Sail Auxiliary - All Group No. 13 Fuel Lines	June 4, 1981	Bulletin No. 13002 (1004)

Subject: New Fuel Hoses (Diesel Auxiliaries)

All Sail Auxiliary Engines (D-7, D-12, D-35 and D-50)

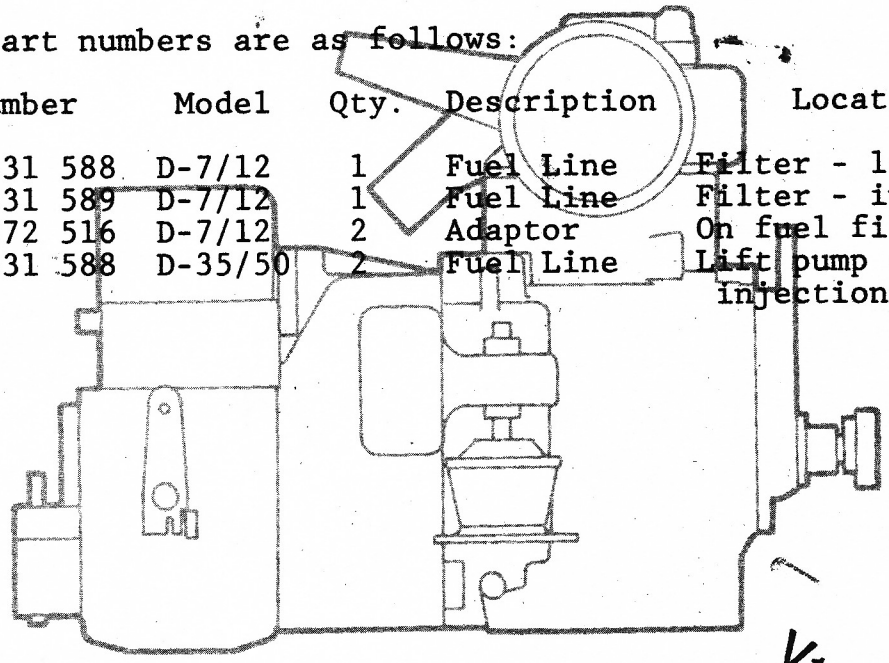
New improved fuel lines have been introduced for the BMW Marine diesel engines. The new fuel lines are metal protected spun rubber hoses with swivel connectors. The new fuel lines will improve sealing and durability. They will be used on future production and will retro-fit previous production models.

Part Number	Model	Qty.	Description	Location
13 31 1 331 588	D-7/12	1	Fuel Line	Filter - lift pump
13 31 1 331 589	D-7/12	1	Fuel Line	Filter - injection pump
07 11 9 972 516	D-7/12	2	Adaptor	On fuel filter
13 31 1 331 588	D-35/50	2	Fuel Line	Lift pump - filter - injection pump
